**IMPORTANT SAFETY RECALL**

**NHTSA Recall No. 15V-781**

**STRICK TRAILERS, LLC #705703 / REAR IMPACT GUARD FIELD RETROFIT INSTRUCTIONS:**

FIELD, INST, RIG, NA VL, 46829/30 FIX, 0045

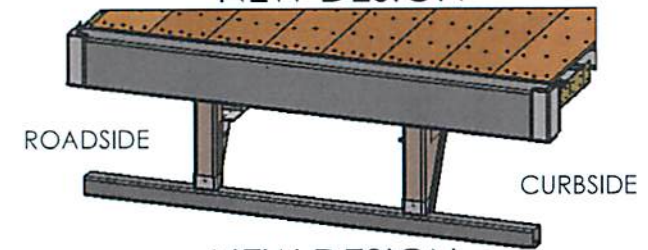
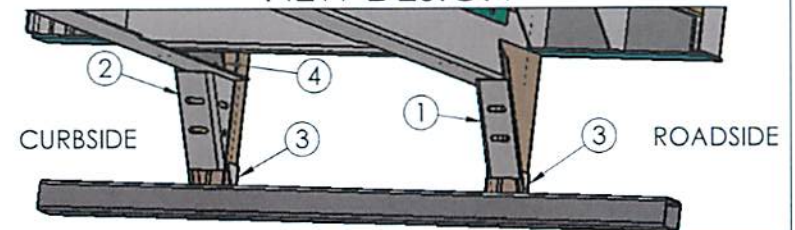
The noncompliance is in regards to the curbside and roadside rear impact guard gussets. Strick Trailers identifies the gussets with the numbers 46829 and 46830. These gussets do not meet the requirements of Federal Motor Vehicle Safety Standard 223 pertaining to rear impact guards. This could increase the risk of injury in the event of a rear impact crash.

**CURRENT DESIGN**

**NEW DESIGN**

**NEW DESIGN**

In order to remedy the noncompliance, it will be necessary to reinforce the curbside and roadside rear impact guard gussets in accordance with the instructions (Drawing 705703) attached to this letter. We will supply the new reinforcement parts without cost and will ship them to multiple locations at your request. The parts necessary to reinforce the gussets are expected to be available for delivery beginning on February 2, 2016. We will also reimburse you for the reasonable direct labor costs involved in effecting the repair or will have the repair facilities bill us directly. The work to reinforce the rear impact guard gussets will take approximately two and one half hours to perform.

3. PREPARE ALL SURFACES TO BE WELDED INCLUDING EXISTING AND NEW BY EXPOSING THE BARE METAL AT THE LOCATION OF THE WELD.
4. POSITION AND WELD ITEM ① AS SHOWN ON SHEET 2.

5. POSITION AND WELD ITEM ② AS SHOWN ON SHEET 2.
6. POSITION AND WELD ITEM ③ ON THE ROADSIDE AND CURBSIDE GUSSET AS SHOWN ON SHEET 2.
7. POSITION AND WELD ITEM ④ IN THE ROADSIDE AND CURBSIDE SUBFRAME CHANNEL AS SHOWN ON SHEET 2.

8. ALLOW ALL NEW WELDS TO COOL BEFORE THOROUGHLY CLEANING AND APPLYING UNDERCOATING, PRIMER, PAINT, OR EQUIVALENT TO PREVENT CORROSION.
9. ANY QUESTIONS REGARDING THE INSTALLATION OF THE REAR IMPACT GUARD RETROFIT SHOULD BE DIRECTED TO STRICK TRAILERS LLC ENGINEERING AT 260-692-6121.
